Access Compliance Report Public Rights-of-Way (Curb Ramps)

Main Street: FLINTRIDGE_AVE Cross Street: PICKERING_CIR Location: N

ADA ID: RPRK211108124251 Ramp Type: Type 4 - Parallel Initial Pass/Fail: Fail Overall Compliance: No Severity Score: 32

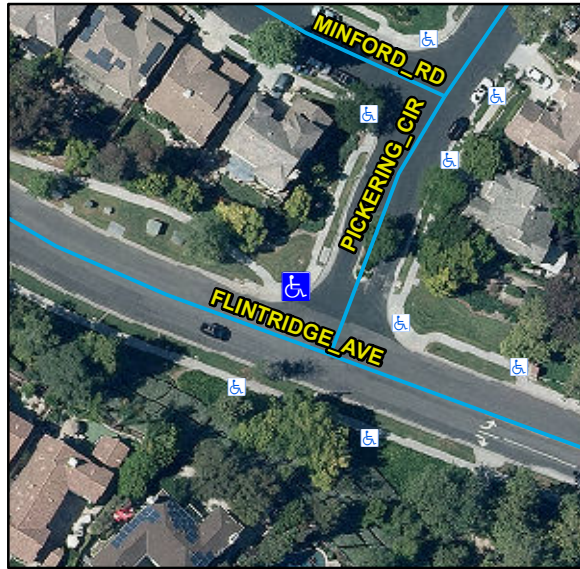
Compliance	Description	Data	Compliance	Description	Data
N/A	Ramp Length LT (in)	117	N/A	Ramp Length RT (in)	108
Yes	Ramp Width LT (in)	90	Yes	Ramp Width RT (in)	90
No	Ramp Run Slope LT (%)	14.2	Yes	Ramp Run Slope RT (%)	7.2
Yes	Ramp Cross Slope LT (%)	1.9	No	Ramp Cross Slope RT (%)	2.1
N/A	Landing Present	N/A	N/A	DWS Provided	N/A
N/A	Landing Length (in)	N/A	N/A	DWS Contrast	N/A
N/A	Landing Width (in)	N/A	N/A	DWS Length (in)	N/A
N/A	Landing Run Slope (%)	N/A	N/A	DWS Full Width	N/A
N/A	Landing Cross Slope (%)	N/A		DWS Offset Type	N/A
N/A	Landing Movement Obstructed?	N/A	N/A	DWS Offset Left (in)	N/A
	Landing Movement Type	N/A	N/A	DWS Offset Right (in)	N/A
N/A	Landing Shared	N/A			
N/A	Clear Space	Yes			
N/A	Clear Space To Crosswalk (in)	N/A			
N/A	Marked Crosswalk 1	No	N/A	Marked Crosswalk 2	No
	Crossing 1 Direction	SW		Crossing 2 Direction	SE
	Marked Crosswalk 1 Width (in)	N/A		Marked Crosswalk 2 Width (in)	N/A

N/A	Ramp Inside Crosswalk 1	N/A	N/A	Ramp Inside Crosswalk 2	N/A
	Crossing 1 Slope (%)	0.7		Crossing 2 Slope (%)	1.2
	Crossing 1 Cross Slope (%)	7.1		Crossing 2 Cross Slope (%)	5.9
N/A	Gutter Ponding	N/A	N/A	Curb Slope	6
Yes	Gutter Lip Height (in)	0		Road Run Slope (%)	7.7
N/A	Gutter Run Slope (%)	N/A		Road Cross Slope (%)	2
N/A	Gutter Cross Slope (%)	N/A	No	Perpendicular Joint Present	No
Yes	Overall Surface Condition	Acceptable			
	Cross Gutter Present?	No		Spandrel Present?	No
	Replace Cross Gutter?	N/A		Replace Spandrel?	N/A

Remove & Replace Curb Ramp With Two New Directional Ramps or Equivalent.

R204.3, R304.3.2, R304.5.3, STD 1115
